# Access Compliance Report

## Public Rights-of-Way

Intersection ID: 23801	Main Street: STEPHENDALE_DR	Cross Street: S_TRYON_ST	Location: SW
ADA ID: D83EE29DBD39	Ramp Type: PerpDiag	Initial Pass/Fail: Fail	Overall Compliance: No
Severity Score: 37.5			
Codes/Mitigation Info/Possible Solution		Field Measurements/Component Compliance

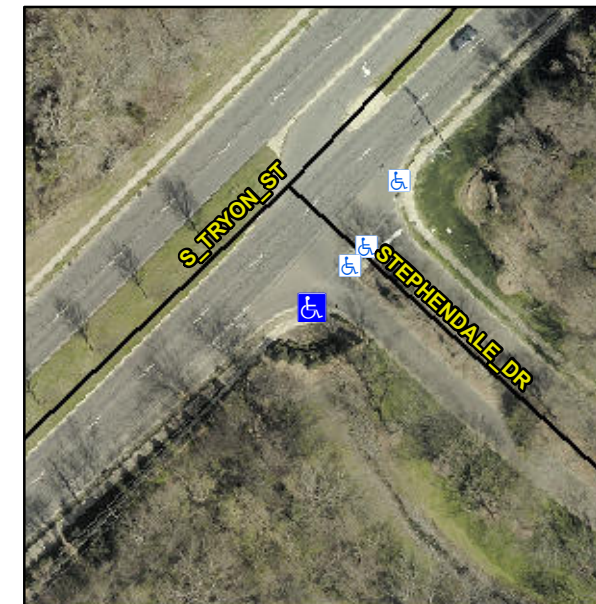
**Remove & Replace Curb Ramp With Two New Directional Ramps or Equivalent.**

**R304.2.2, R304.5.3**

Compliance	Description	Data	Compliance	Description	Data
N/A	Ramp Length (in)	90.0	No	Ramp Slope (%)	11.4
Yes	Ramp Width (in)	51.0	No	Ramp XSlope (%)	7.0
N/A	Flare Type LT	N/A	N/A	Flare Type RT	N/A
N/A	Flare Slope LT (%)	N/A	N/A	Flare Slope RT (%)	N/A
N/A	Flare Traversable LT?	N/A	N/A	Flare Traversable RT?	N/A
N/A	Landing Length (in)	N/A	N/A	DWS Provided?	N/A
N/A	Landing Width (in)	N/A	N/A	DWS Contrast?	N/A
N/A	Landing Slope (%)	N/A	N/A	DWS Length (in)	N/A
N/A	Landing X Slope (%)	N/A	N/A	DWS Full Width?	N/A
N/A	Landing Curb? (Y/N)	N/A	N/A	DWS Offset (in)	N/A
N/A	Shared Landing?	N/A			
N/A	Gutter Ponding?	N/A	N/A	Gutter Slope (%)	N/A
N/A	Gutter Lip Ht (in)	N/A	N/A	Gutter X Slope (%)	N/A
N/A	Painted X Walk1?	No	N/A	Painted X Walk2?	No
	X Walk 1 Direction	To NE		X Walk 2 Direction	To NW
N/A	X Walk 1 Width (in)	N/A	N/A	X Walk 2 Width (in)	N/A
	X Walk 1 Slope (%)	3.6		X Walk 2 Slope (%)	9.8
	X Walk 1 X Slope (%)	7.0		X Walk 2 X Slope (%)	1.6
